**Subject:** Adjustment of the actuation system for the water ballast valves.

**Applicability:** all ASW 27-18 „ASG 29“ and ASW 27-18 E „ASG 29 E / Es“

**Fig. 1 – Adjusting the Bowden cables**

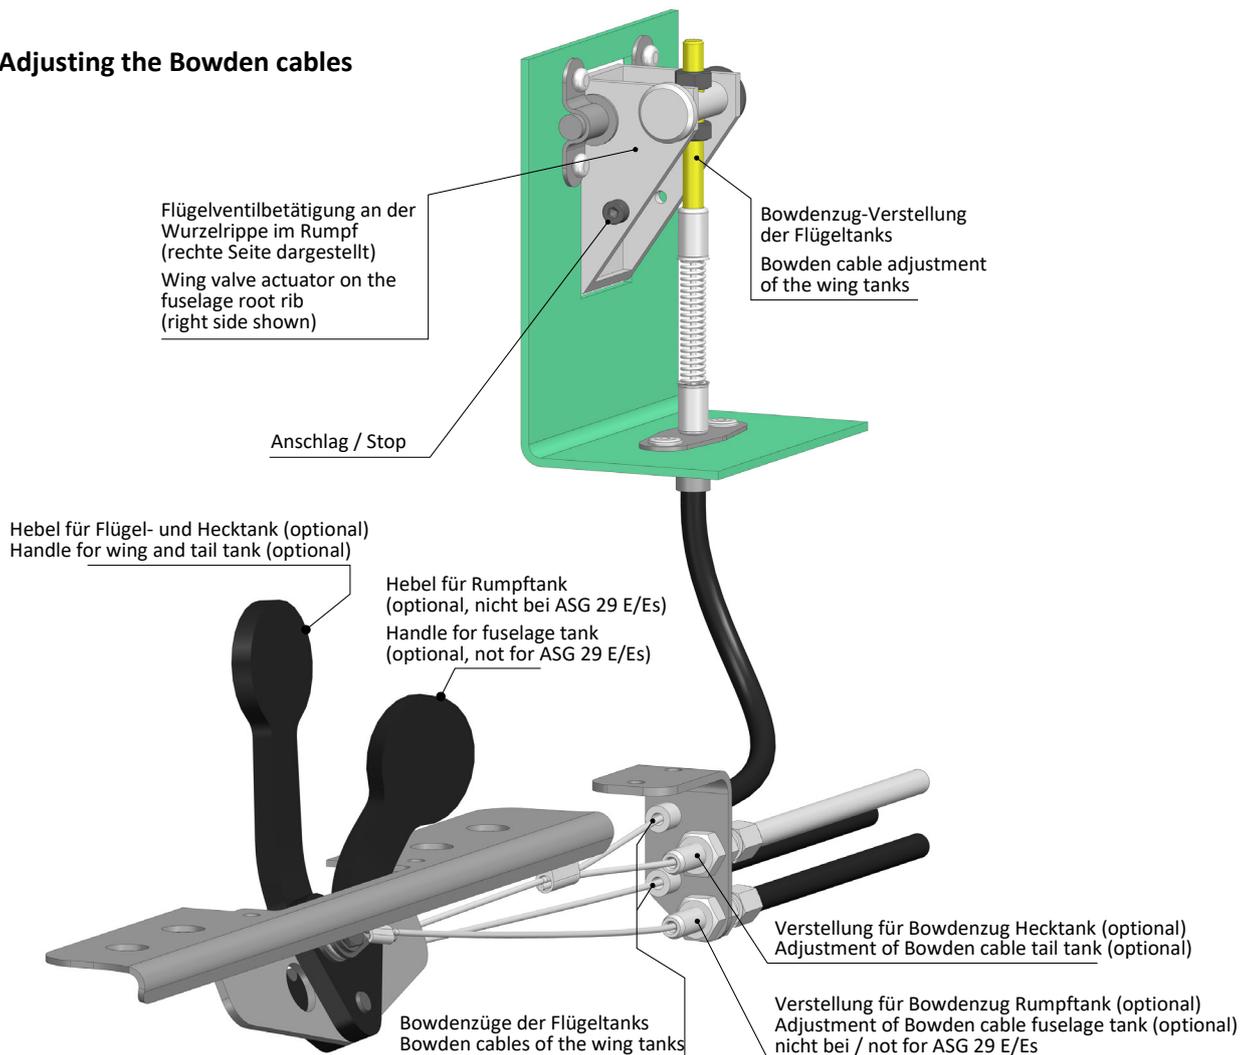
For an equal operation of the water ballast valves, the Bowden cables of the system can be adjusted at different positions (see Fig. 1). They must be adjusted in the following manner:

**Wing tanks:** The valve actuator at the fuselage root rib incorporate a stop preventing them from rotating too far out of the fuselage. In the “valve open”-position they rotate nearly up to the stop. The adjustment is made directly on the threaded piece at the end of the Bowden cable (see Fig. 1).

**Tail tank (optional) / fuselage tank (optional, not for ASG 29 E/Es):** The Bowden cables are adjusted such, that they are unloaded / slack in “valve closed” position. They can be adjusted at the mounting bracket behind the handle (see Fig. 1).
